PROJECTILE, 76MM/62 CALIBER, MK -- FROM AISI 9260 STEEL

Naval Weapons Laboratory  
Dahlgren, Virginia

FINAL REPORT

Contract N00178-74-C-0030

MANUFACTURING'S FLOW DIAGRAM

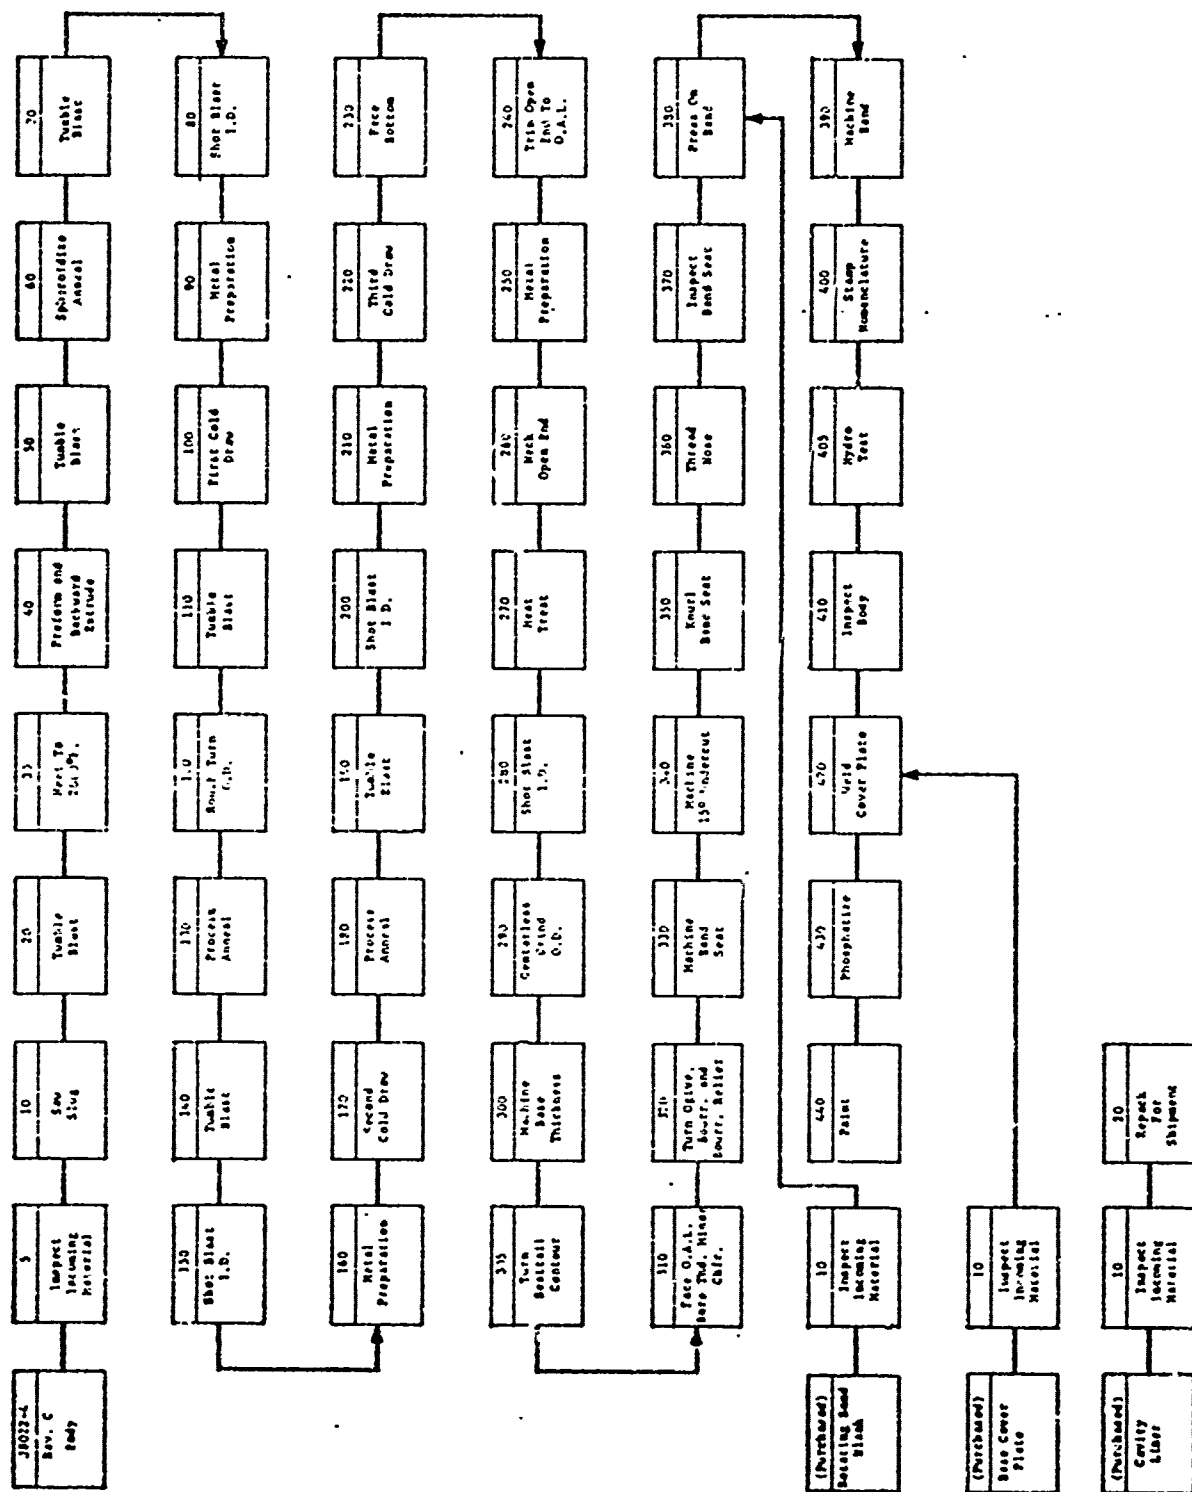
- ② C 02-A-225/A - FOLKED, DENMARC WOLD  
FINISHED BRASS, 100, AND VIBRE.  
AFTER FIRST MEETING IN ACCORDANCE WITH  
MILAN 1908. FINISH MECHANICAL OPERATING SHALL  
BE ACCORDING WITH TESTED IN ACCORDANCE  
WITH ASTM A58 THAT TEST SPECIFICATION.
